Attachment 5

Proposed Revisions to the July 3, 2019 Campus Town Specific Plan

Figure 2.9 - Conceptual Bicycle and Trails Network Diagram

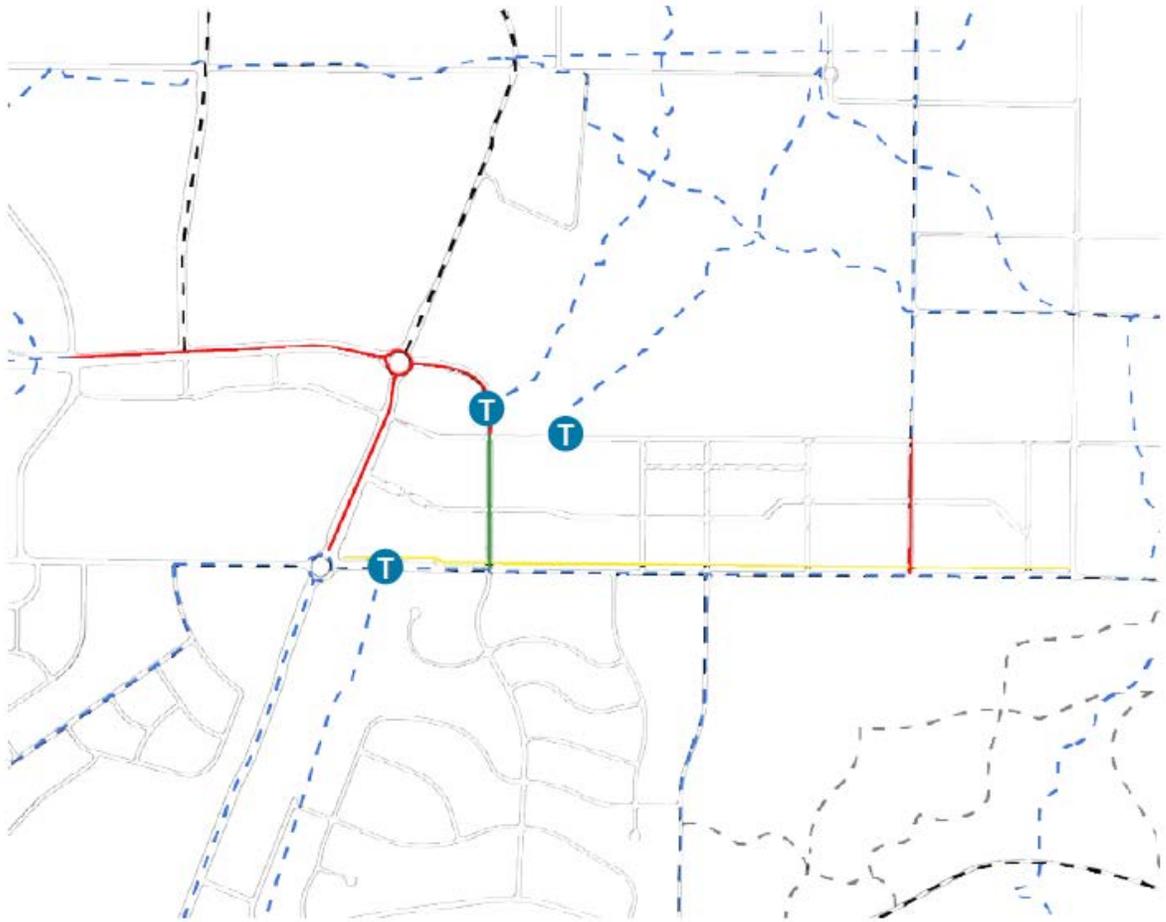
Page 37, Updated Figure 2.9:
